DRAWN	CHECKED	APPROVED	MATERIAL : PHENOL	UL REC. : UL94V-0	THIRD ANGLE PROJ.	SCALE : 1/1
Dae Soo, Kim	Hyoung Seok, Lee	Hyoung Seok, Kim	Z : PIN LENGTH (According to customer's request)	DATE : 2007.12.10	TOLERANCE : ±0.2 (Unless otherwise specified)	UNIT : m/m
주식회사 대흥보빈 DAE HEUNG BOBBIN CO., LTD			TITLE EE 25*27 (13P) "V" (B)		DWG NO DH-071210-2039-05

A-A SECTION

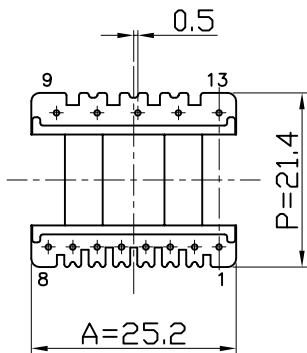
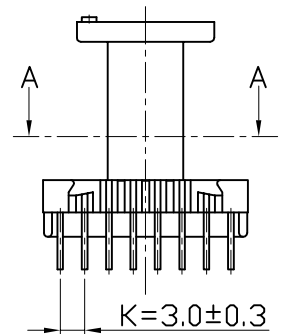
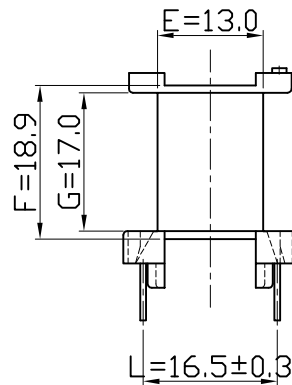
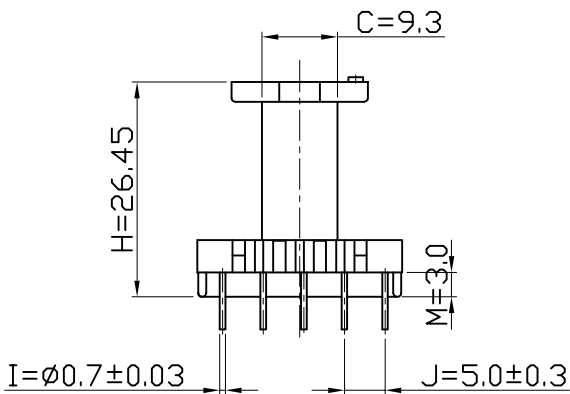
1. 2차측 9~13번 PIN을 13번 PIN 방향으로 0.5mm 변경
